# Work Order ID 69731

Item Name: 205 Skidtube bent detail

DRAWING NO. D2580	TITLE 205 SKIDTUBE ASSEMBLY	REV. D	DART AEROSPACE LTD ENGINEERING ORDER		D.E.O. NO. D2580-D-1	SHEET NO. SHEET 1 OF 1	SCALE NTS
DRAWN <i>UP</i>	CHECKED <i>L</i>	MFG. APPR. <i>E</i>	APPROVED <i>MP</i>		DE APPR. <i>H</i>		
DATE 10.09.22	DATE 10.11.04	DATE 10.11.04	DATE 10/11/04		DATE 10.11.04

CHANGE ALL WELDED CROSSBOLT SPACERS TO SWAGED SPACERS

SECTION D-D & SECTION H-H ARE AMENDED AS FOLLOWS:

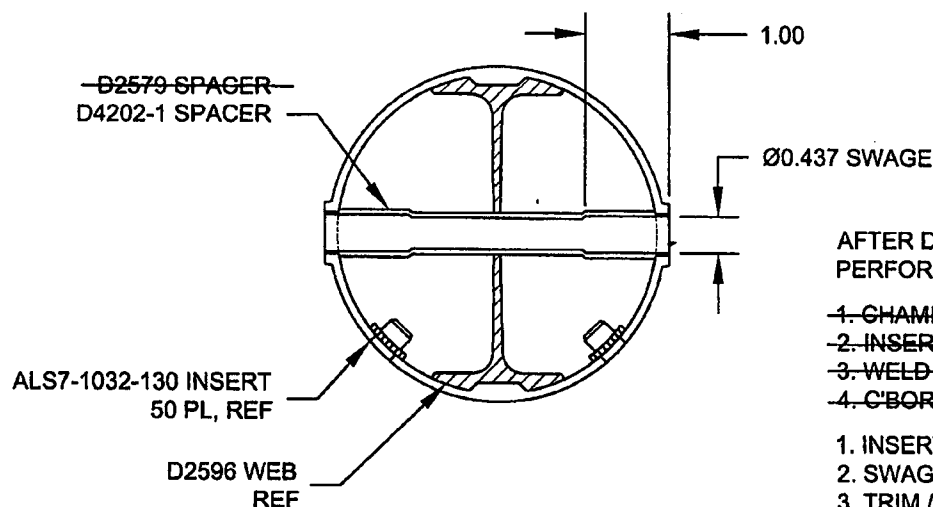
AFTER DRILLING AND BENDING ASSEMBLY  
PERFORM THE FOLLOWING FOR Ø0.508 HOLES ONLY:

- ~~1. CHAMFER HOLE 0.050 X 45°~~
- ~~2. INSERT D2579 SPACER (20 PLACES)~~
- ~~3. WELD INTO PLACE AND GRIND FLUSH~~
- ~~4. C'BORE D2579 SPACER TO Ø0.437 X 1.00 DEEP~~

1. INSERT D4202-1 SPACER, 20 PL (-041) OR 24 PL (-045)
2. SWAGE TO Ø0.437 X 1.00 DEEP PER QSI 002
3. TRIM / GRIND FLUSH PER QSI 002
